DS-K1T344 Series MinMoe Terminal
Release Notes (2025-07-30)

Device Model: DS-K1T344MX-E1, DS-K1T344MBWX-E1, DS-K1T344MBWX-QRE1, DS-K1T344MBFWX-E1 DS-K1T344MFX-E1 DS-K1T344EX-E1 DS-K1T344EBWX-E1 DS-K1T344EBWX-QRE1 DS-K1T344EBFWX-E1 **Naming Rule:** M for M1 card, E for EM card -E1 for POE, B for Bluetooth F for Fingerprint, W for Wi-Fi -QR for QR code reader	Firmware Version	ACS_344_F2pro_EN_STD_V4.47.0_build250722 ACS_344_F2pro_EN_NEU_V4.47.0_build250722
	Software	**HikCentral Access Control:** https://www.hikvision.com/en/support/download/software/hikcentral-access-control-v2-3-1/ **Please add device to HCP/HC AC with port 80, and port 8000 will not work**

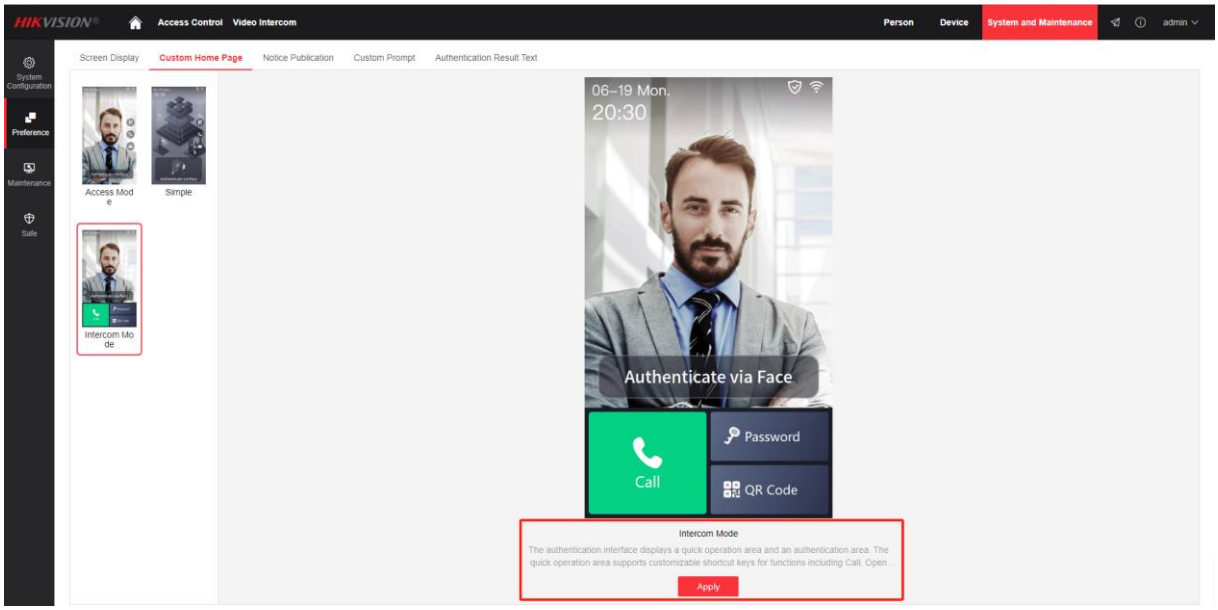
8. Support platform anti-pass back (only act as sub device, while main device is customized 805)
